A RESOLUTION AUTHORIZING THE ISSUANCE OF AN AMENDATORY SUPPLEMENTAL CHANGE ORDER NO. 1, TO CONTRACT NO. C15-0087 ISSUED TO CHARLES MARANDINO, LLC, MILMAY, NJ, IN THE AMOUNT OF \$62,459.20

Amendatory Supplemental Change Order No. 1
Contract No. C15-0087
Completion of Landis Avenue Resurfacing Project Phase 1
Charles Marandino, LLC, Milmay, NJ

RE: Resurfacing of Landis Avenue Phase 1
Myrtle Avenue to Boulevard
Federal Project No. STP-1030 (108) CON
City Eng. File No. 15-002

CONSTRUCTION FIELD ORDER

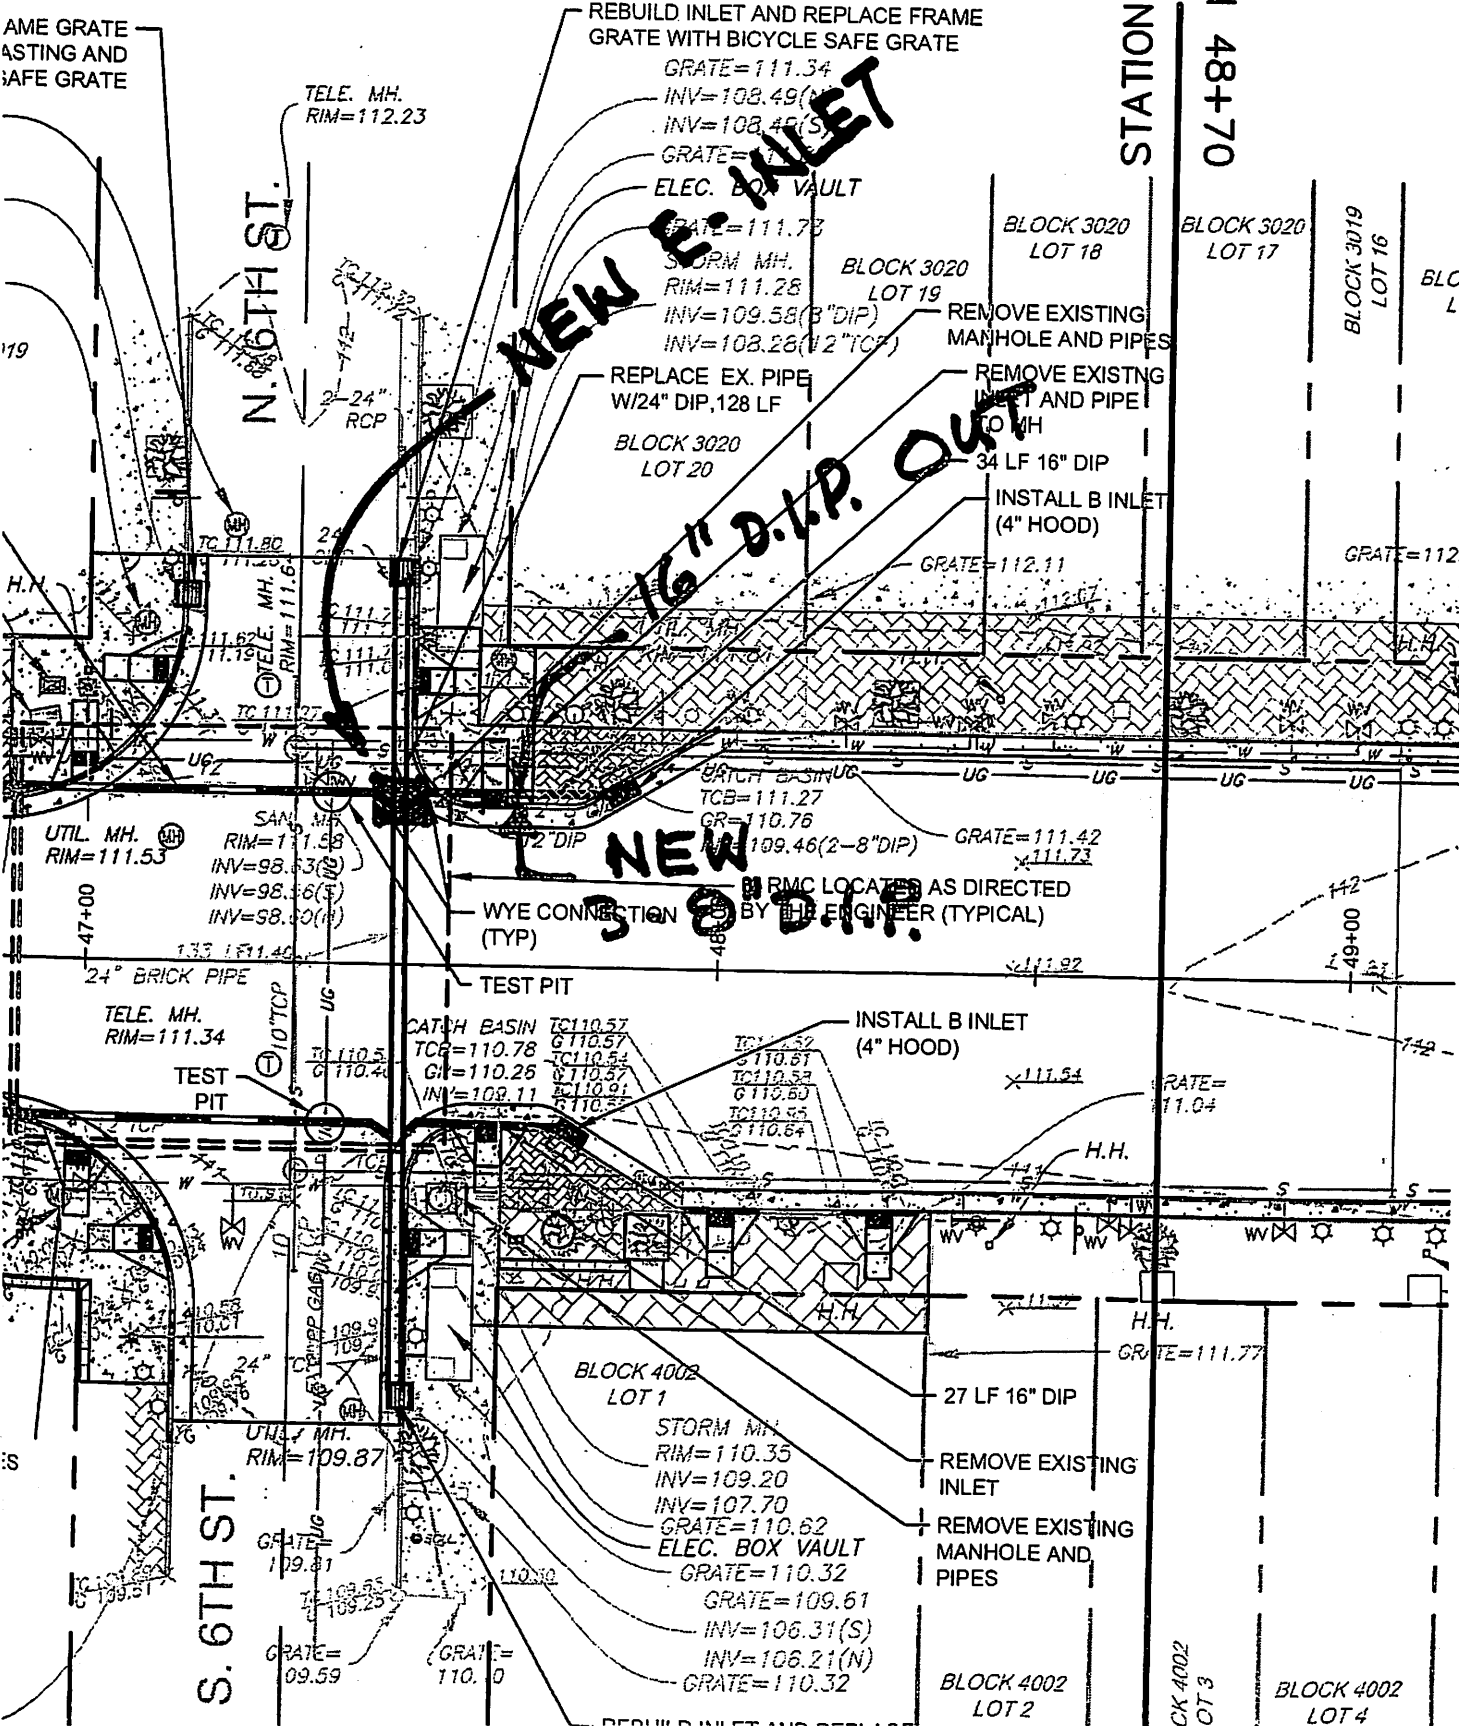
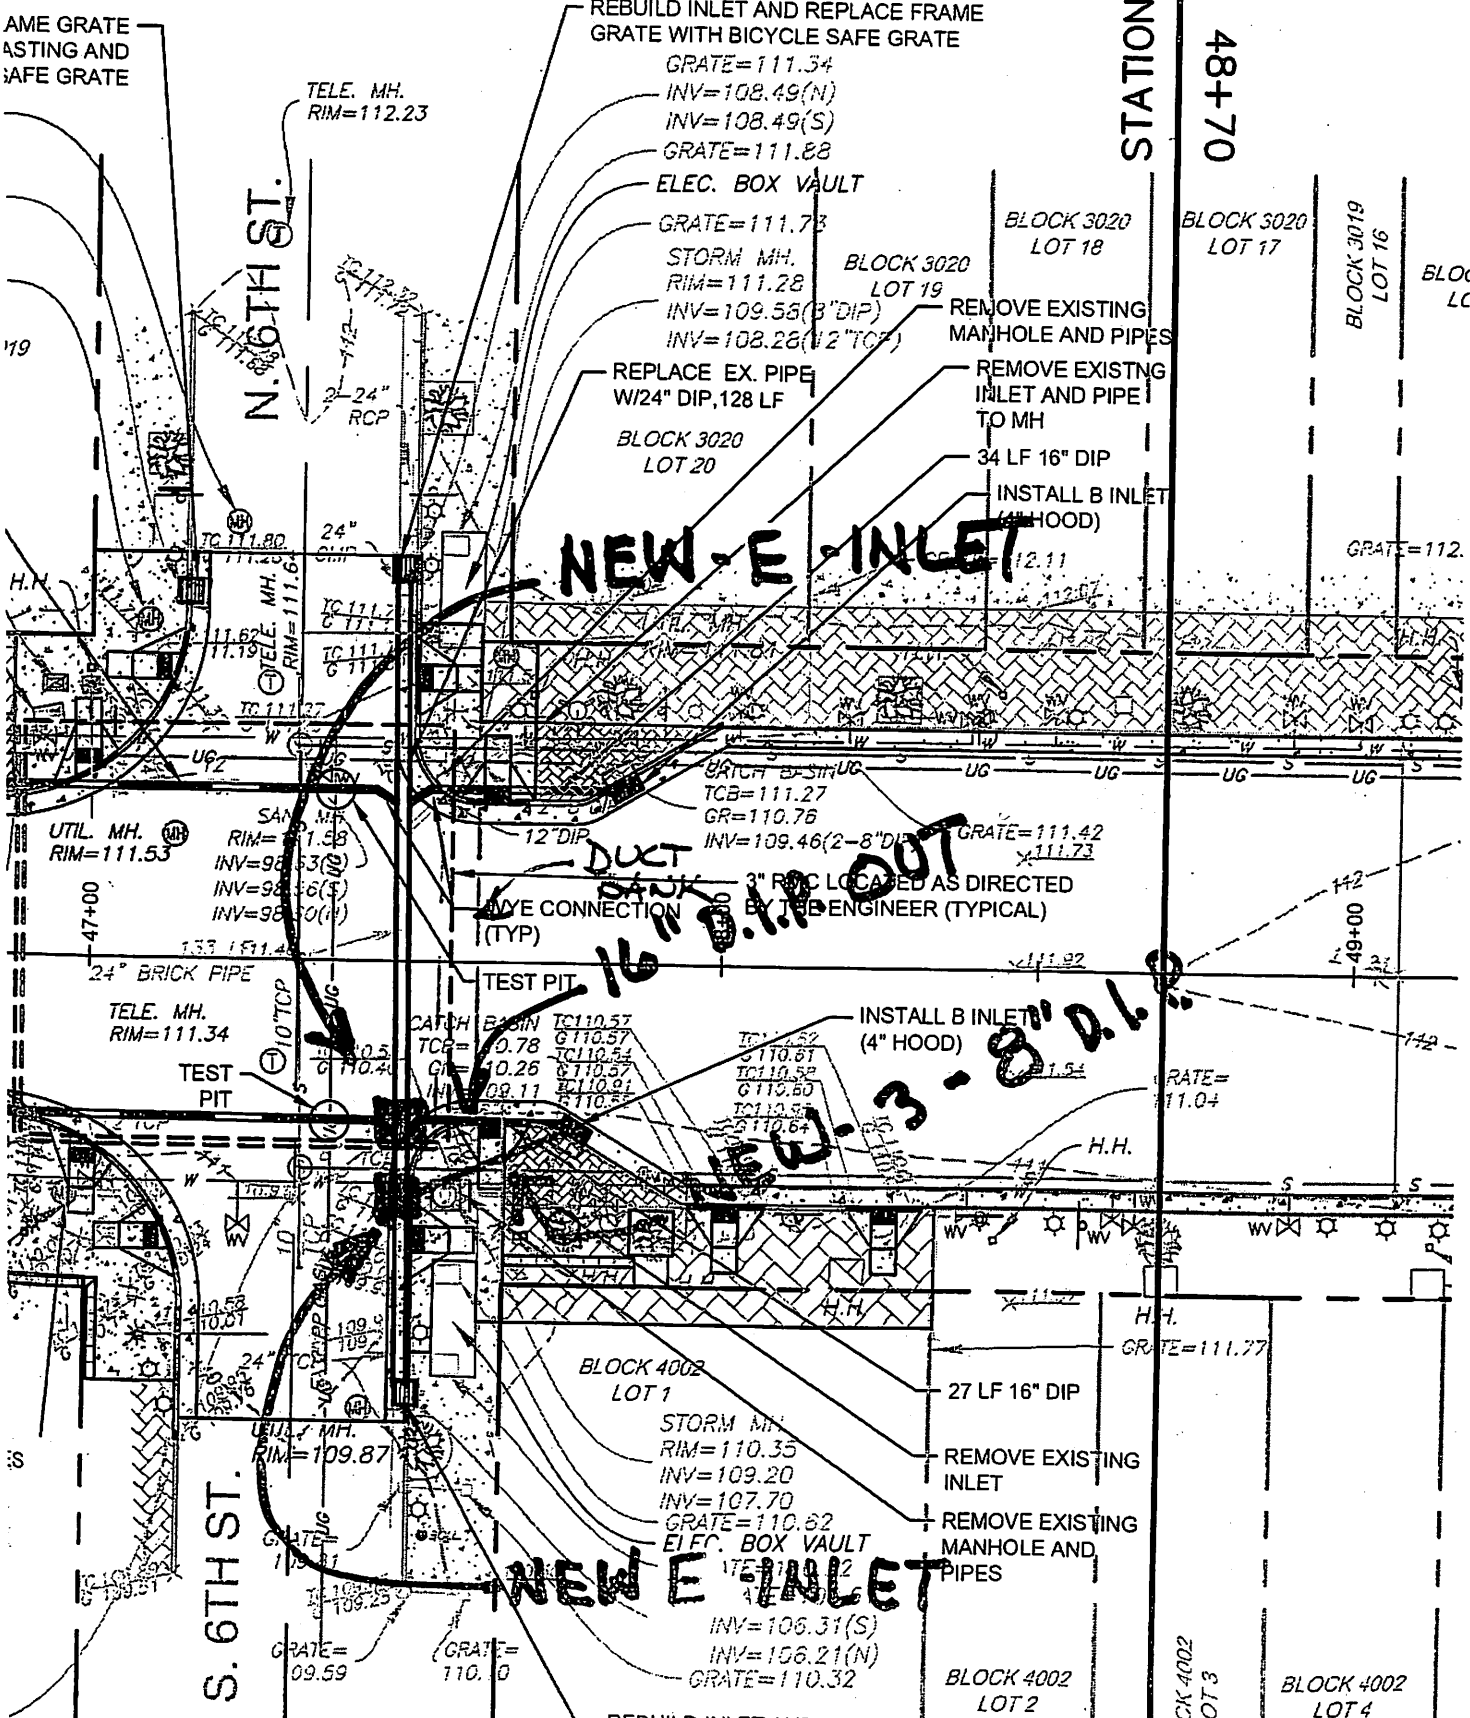
7 th St. Southwest corner – No clearance above the duct bank for 16" pipe. Solution is to eliminate the proposed westerly inlet and piping and install a trench grate system above the duct bank, which will terminate at the curb. A new A inlet will be constructed at this location.
6 th St. Southeast corner – The duct bank appears to follow the grade of the roadway and was not installed level. So, we are not able to follow the path of the proposed 16" pipe. Instead, we are able to install three – 8" pipes above the duct bank in the vicinity of an existing crossing of twin – 6" pipes. This results in a need to install a new A inlet. In addition, it was decided to abandon the concept of wyes and, instead, install inlets for these junction points. Another A inlet will also be installed in this area. See sketch.
6 th St. Northeast corner – There is sufficient room above the duct bank to install three – 8" pipes. The pipes will tie into a new E inlet. See sketch.
